Technical Review Comments

Peacock Jazz & Blues Club

**Re: Technical Review – Waiver of Distance
Celebrity Peacock Jazz & Blue Restaurant**

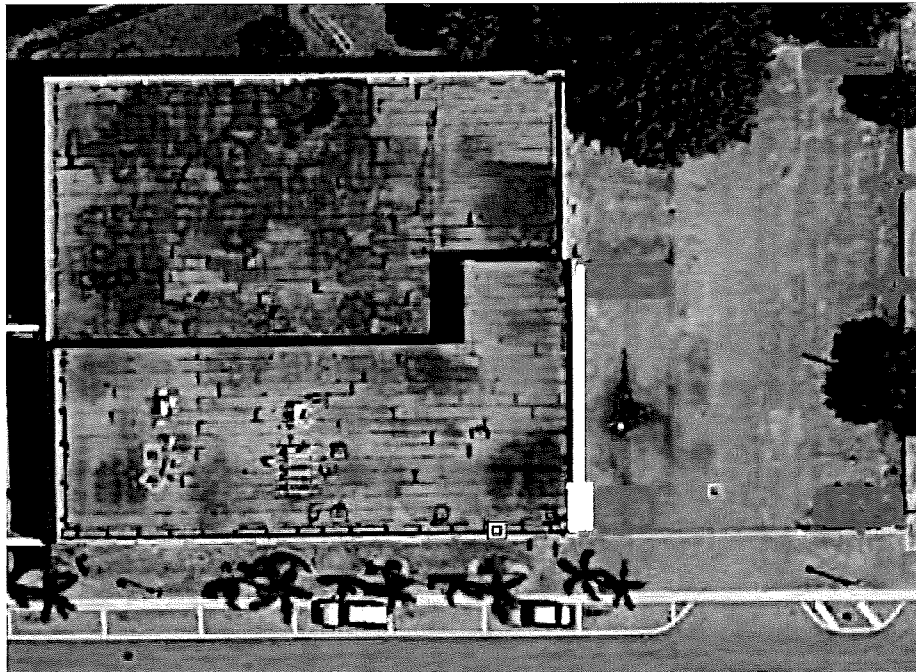
- 4) Per Section 22-187(4) *Landscape strips*. a. & b. Landscaping must be installed at the southern portion of the parking area to adequately screen the lot from the right-of-way. Furthermore, the addition of trees along the eastern property line are required to meet the requirements of City Code Section 22-187(6).

Please see the conceptual below:
